Subject: Submission for Planning Commission Packet – File No. SP24-0016
Attachments: StPaulLetter.pdf

Attached please find my letter regarding the St. Paul Lutheran School site plan at **495 Earhart Road**, along with **Exhibits A, B, and C**, for inclusion in the Planning Commission packet and project record for the **January 21, 2026** meeting (**File No. SP24-0016**).

I am writing as an adjacent property owner to the St. Paul Lutheran School project at **495 Earhart Road** to ensure the Commission has a complete technical record prior to taking action on the site plan.

Exhibit A:
Existing Parking Layout and Circulation - St Pa
(No headlight projection to Waldenwood h

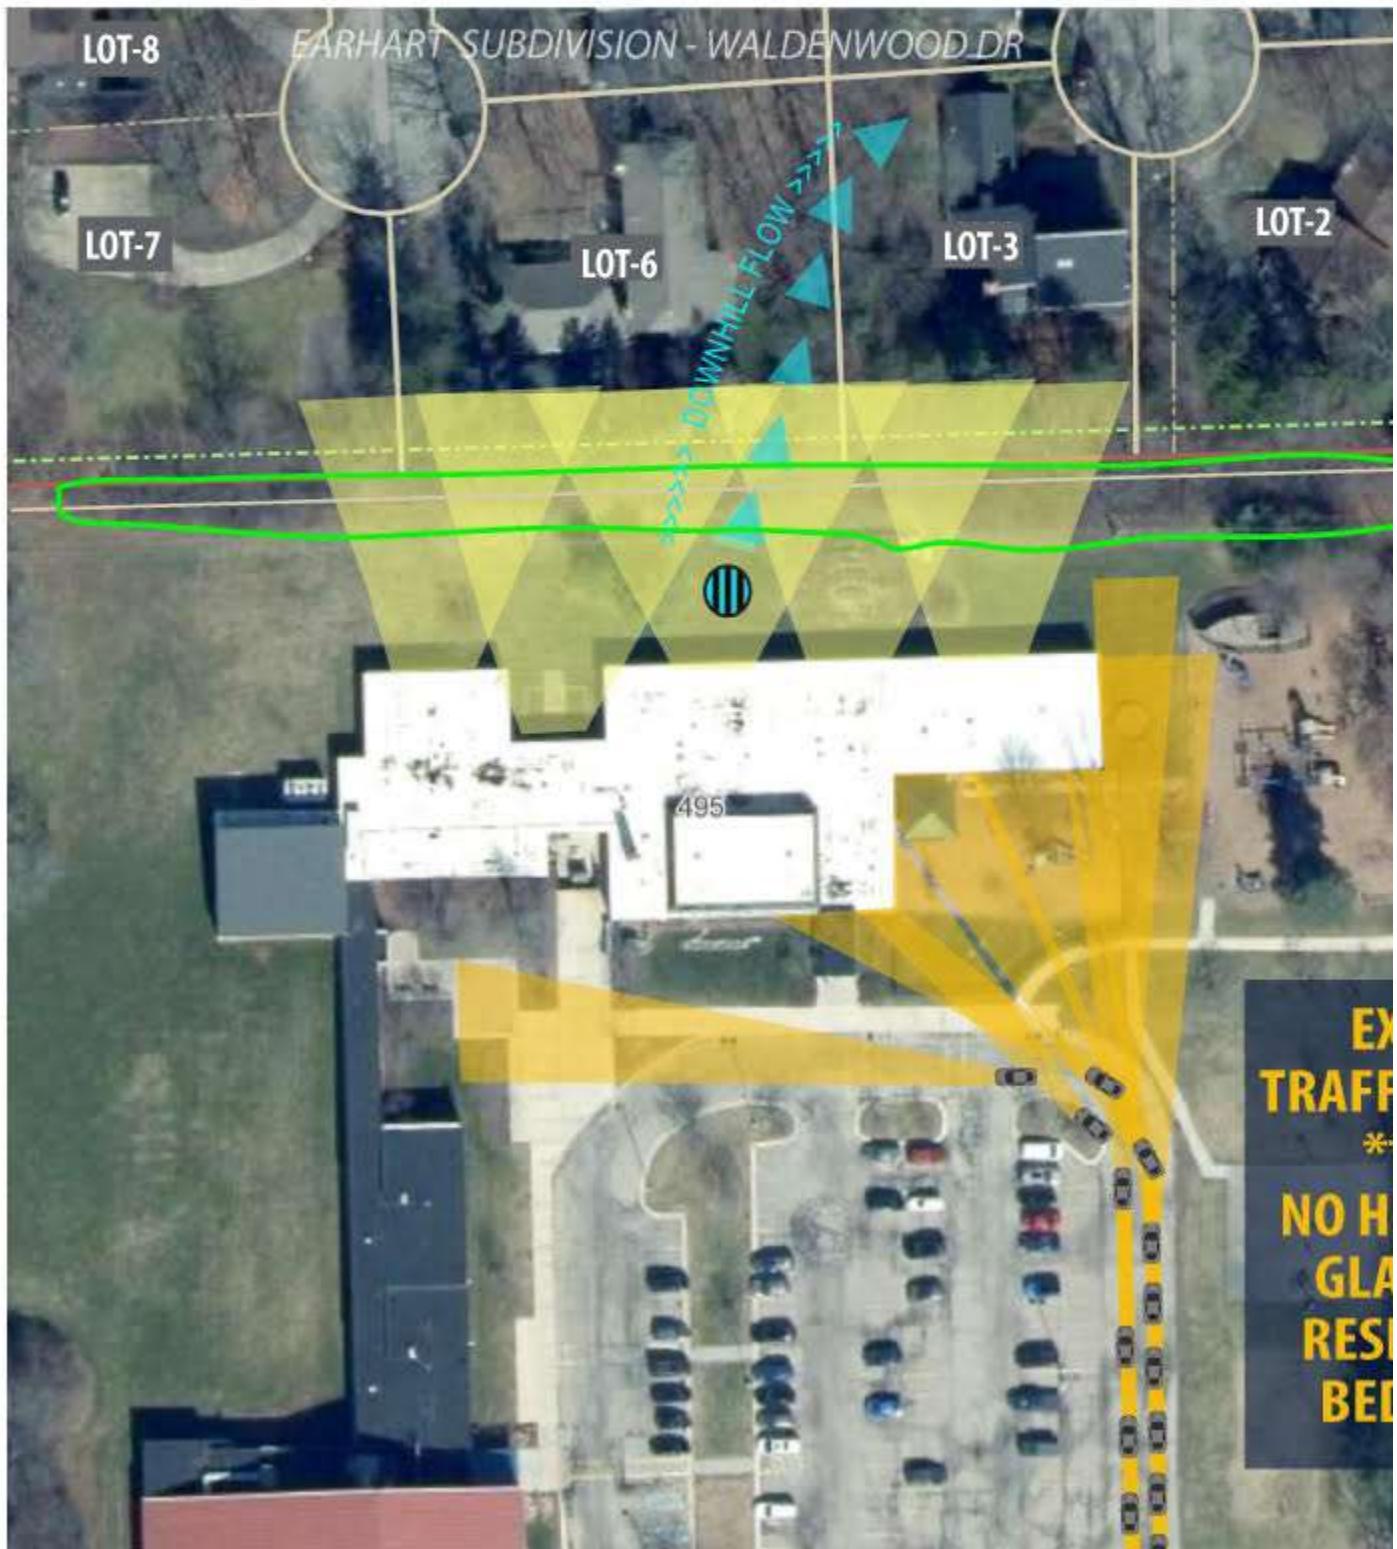
Existing layout complies with UDC §5.29 (Site Circulation)

Exhibit B:
Proposed Parking Layout and Circulation - St P
(Introduces headlight projection to bedroom windows)

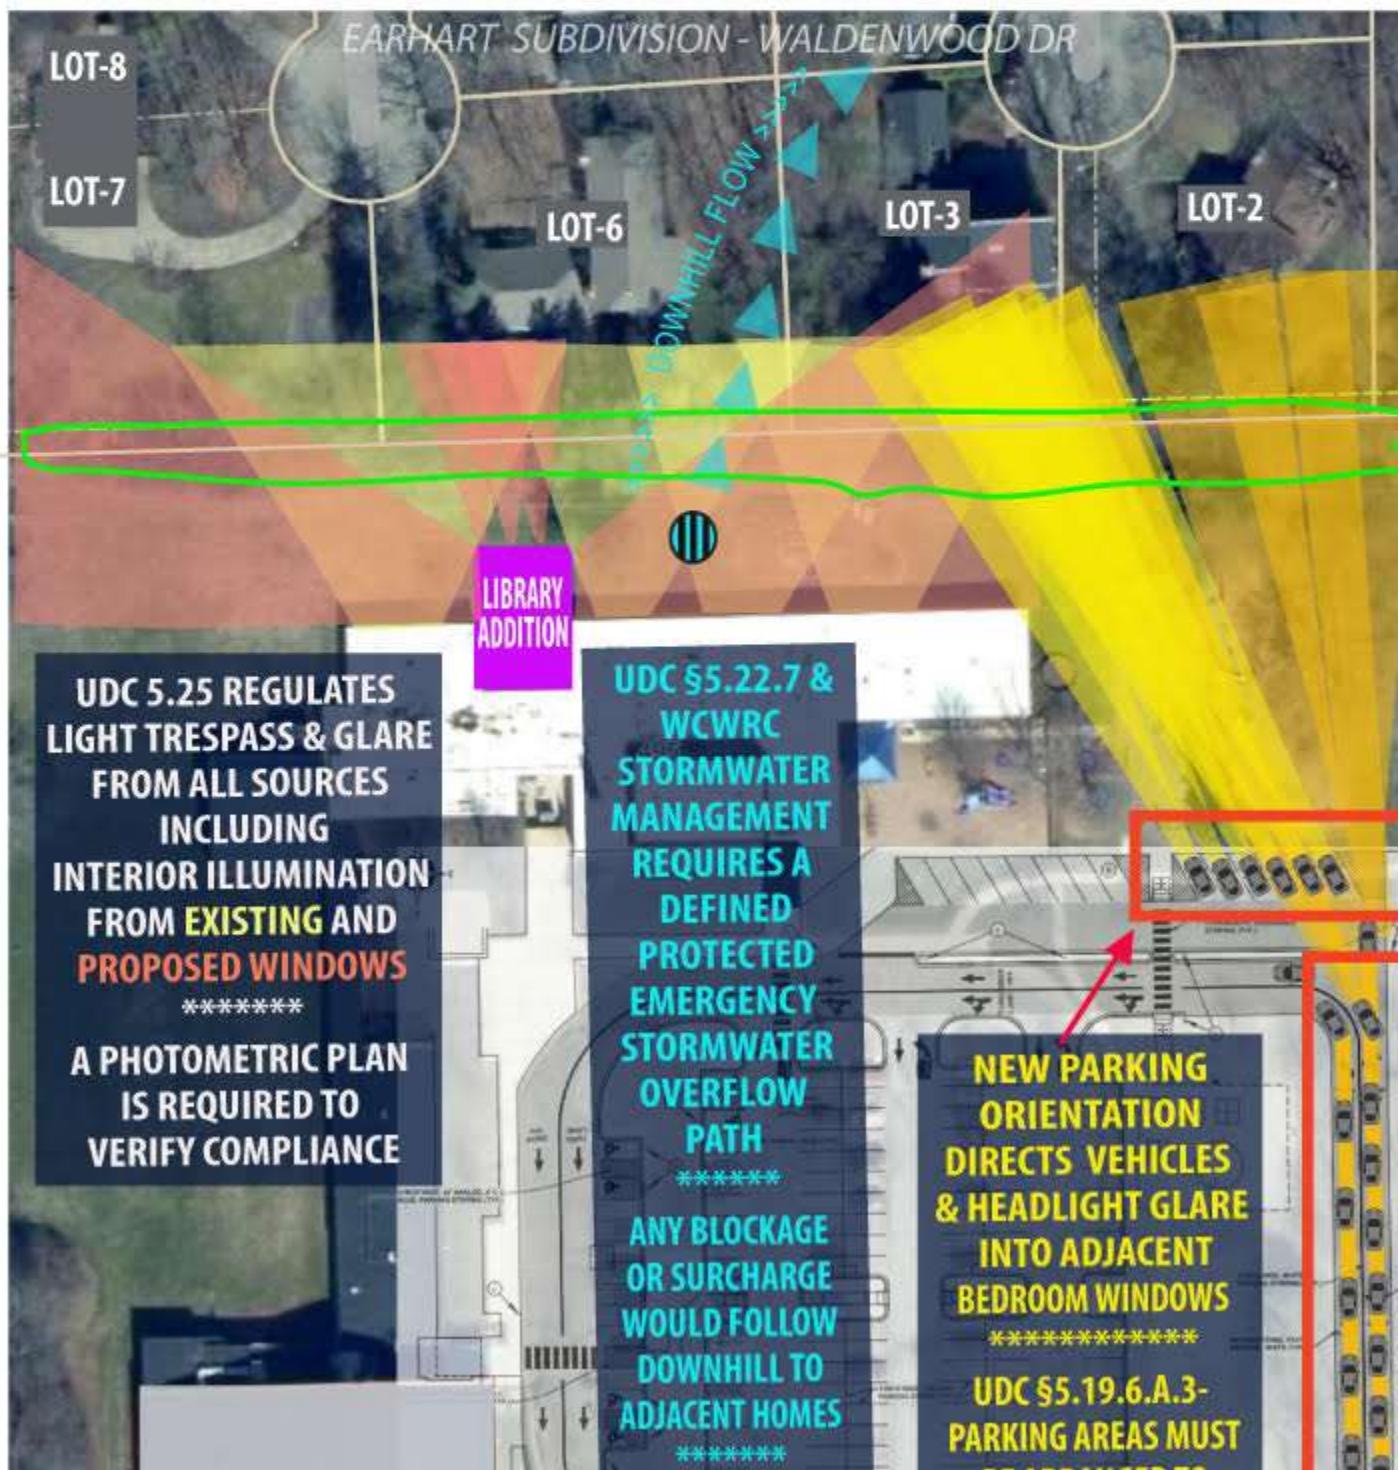
Proposed layout does not comply with:

UDC §5.29.6.B.3 (Parking stalls pointed toward bedrooms)
UDC §5.19.6.A.3 (Parking area must be arranged to prevent nuisance to occupants adjacent to parking areas)

The revised site plan reorients parking stalls and the northbound vehicle queue such that low-beam headlights are directed toward adjacent homes in the Earhart Subdivision, including bedroom windows. This condition does not exist today and is created solely by the proposed circulation and stall orientation.

While exterior lighting has been discussed, the record does not demonstrate how vehicle-generated glare toward residences has been evaluated or mitigated, as required by **UDC §§ 5.29.6.B.3 and 5.19.6.A.3**.
